PLANNING COMMISSION MEETING

April 4, 2024 - 6:00 PM
City Hall Council Chambers

To: Planning Commission
From: Kris Jenson, Planning Manager
Date: March 27, 2024
Subject: Packet Material for the April 4, 2024 Planning Commission Meeting
Agenda Item: Autumn Hill preliminary plat
Action Deadline: May 15, 2024

UTILITY PLAN

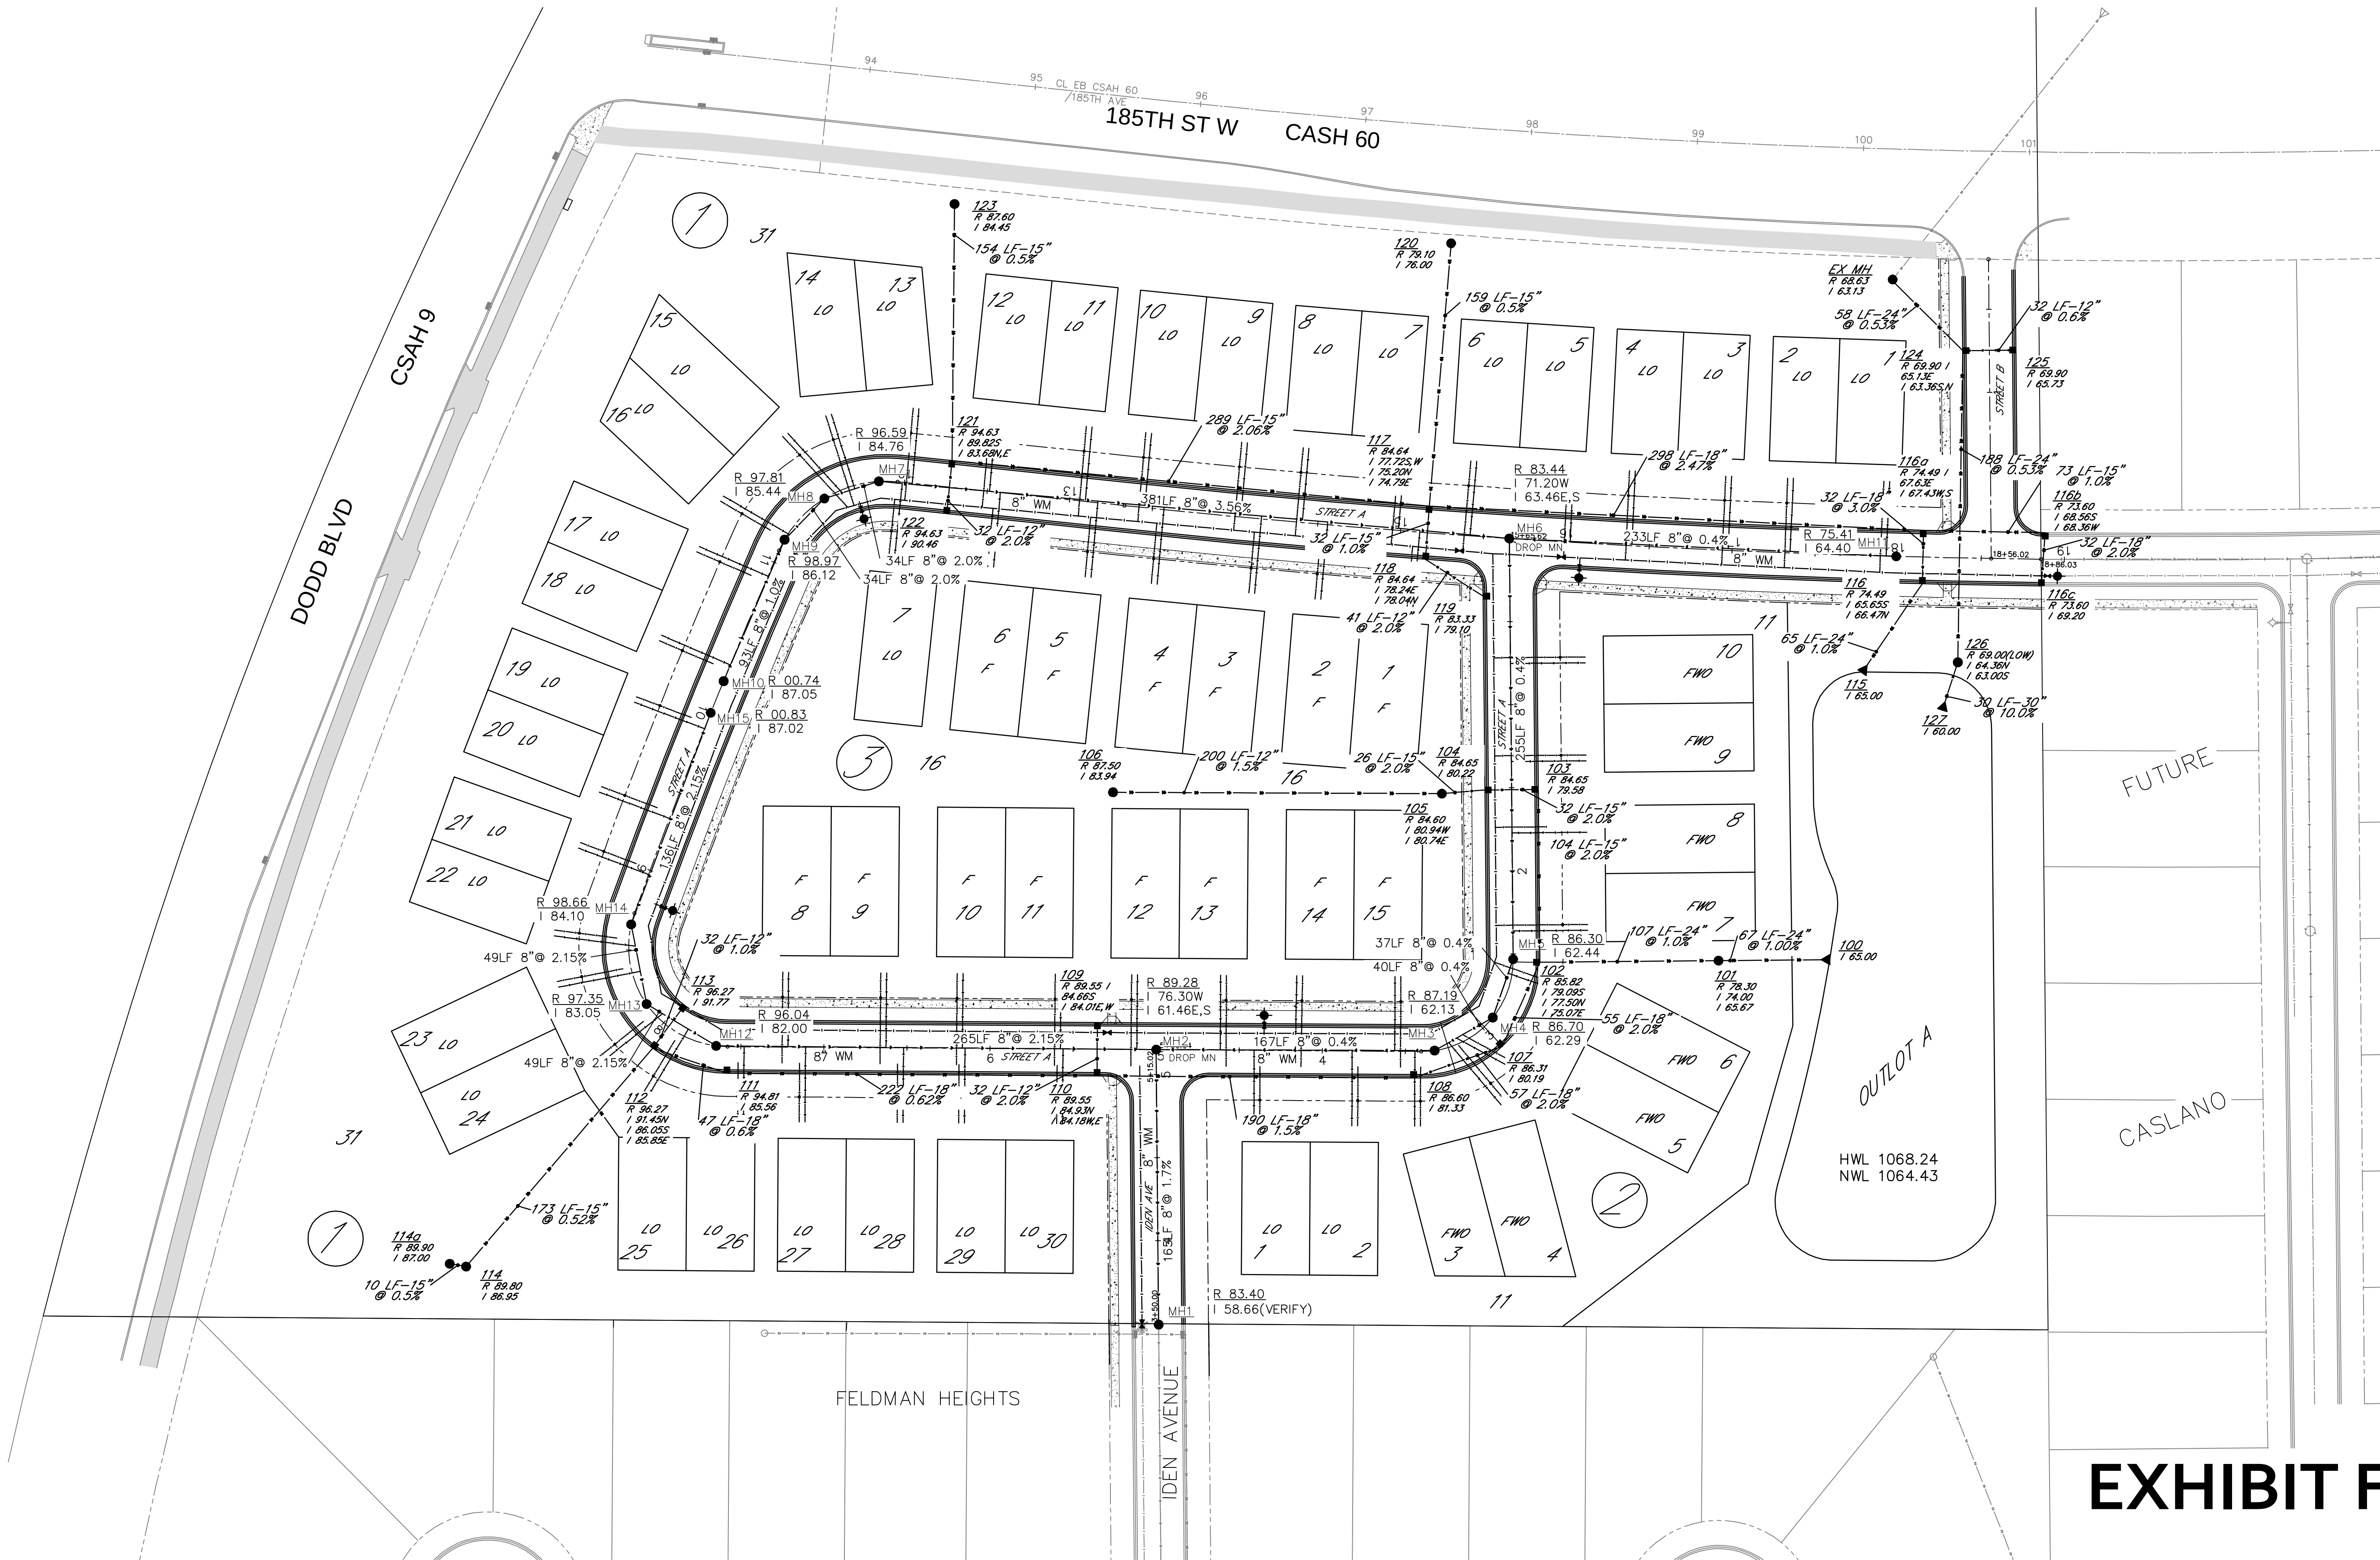
Grading, Drainage, Erosion Control, and Utilities. Proposed grading, drainage, erosion control, and utilities for the Autumn Hill preliminary plat is shown on the grading, drainage and erosion control and utility plans. All existing and new local utilities shall be placed underground.

Grading, drainage, erosion control, and utilities details are outlined in the March 27, 2024 engineering report prepared by Kris Keller and Kendra Fallon, Project Engineers from WSB, on behalf of the Engineering Division. The Engineering Division recommends approval of the preliminary plat.

1. Implementation of the recommendations listed in the March 27, 2024 engineering report.
2. Park dedication shall be satisfied with a cash contribution paid with the final plat.

TREE INVENTORY
PLAN

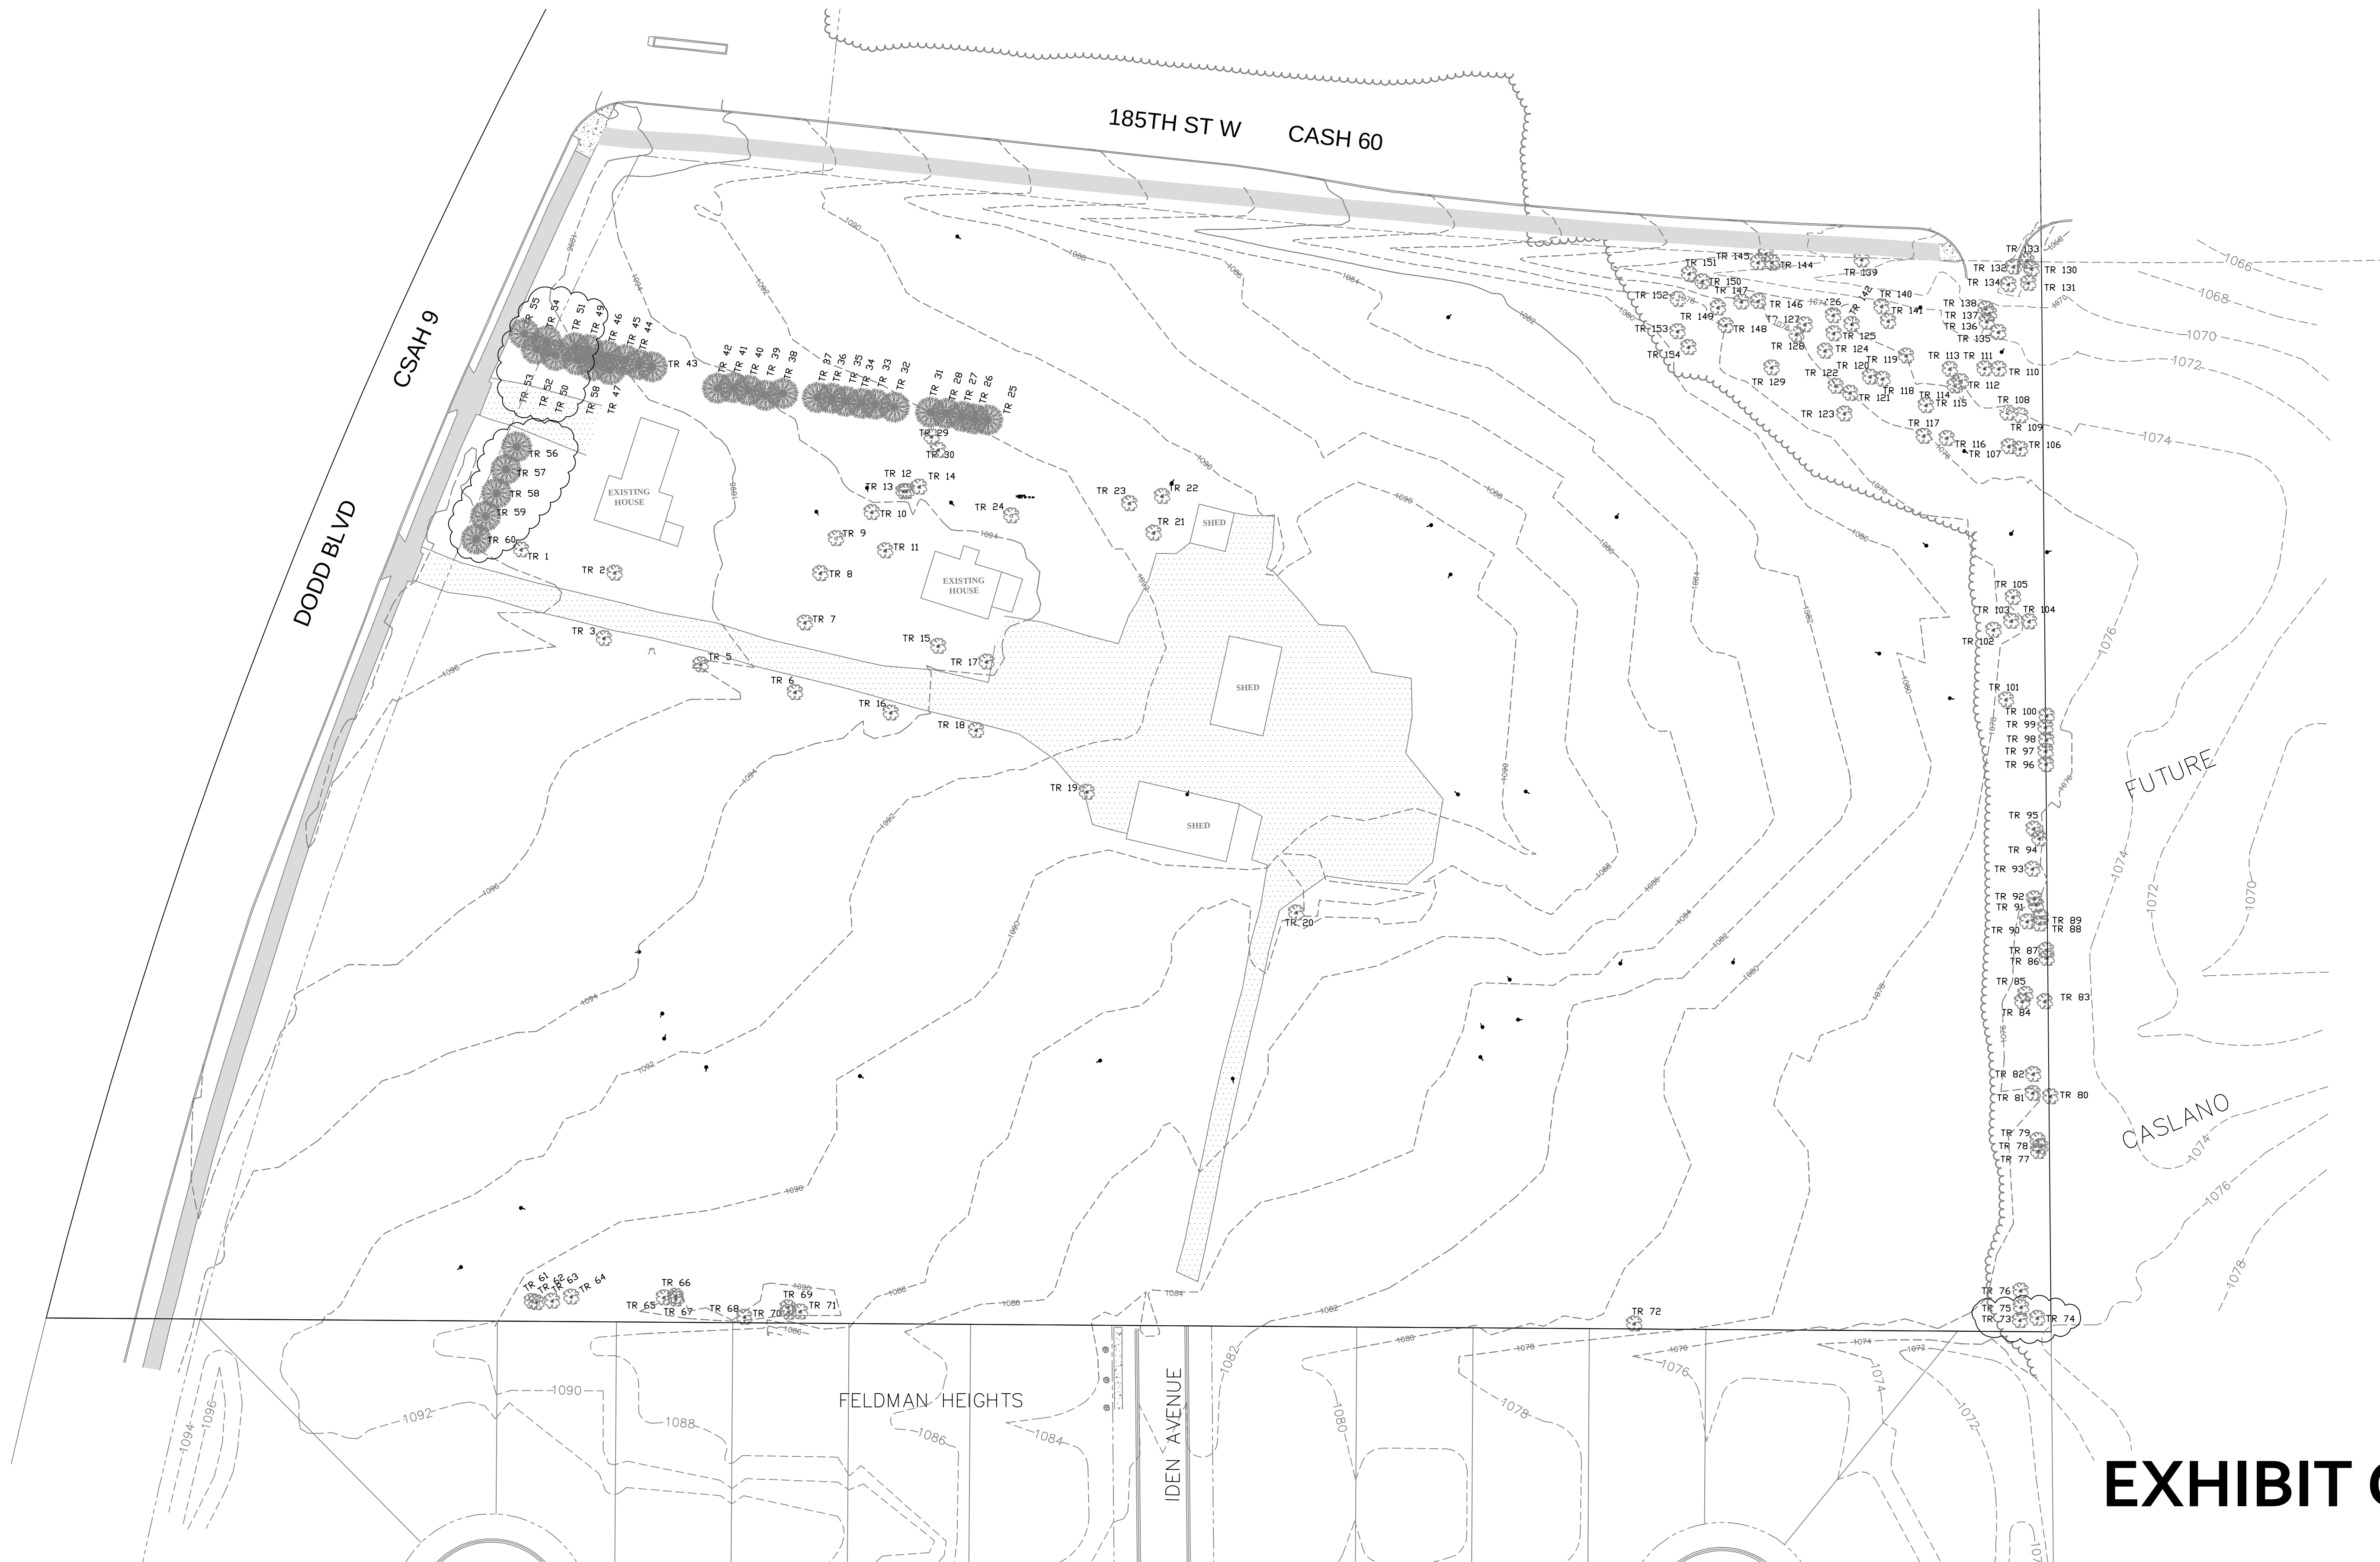
Tree Inventory. A tree inventory was submitted by the developer. There are 155 significant trees located within the Autumn Hill preliminary plat boundary. The plan proposes to save 12 (7.8%) blue and white spruce trees located along Dodd Boulevard.

A tree preservation/inventory plan was submitted by the Developer. There are approximately 155 significant trees located within the preliminary plat boundaries. The majority of the trees will be removed for the grading of site.

6. Within Lot 31, Block 1, the Developer must install sod with the buffer yard plantings to the trails along 185th Street and Dodd Boulevard.
7. Prior to City Council consideration, the landscape plan must be modified to include a combination of overstory, understory, evergreens and shrubs across the site and to incorporate the 12 spruce trees indicated as save trees on the tree inventory plan.
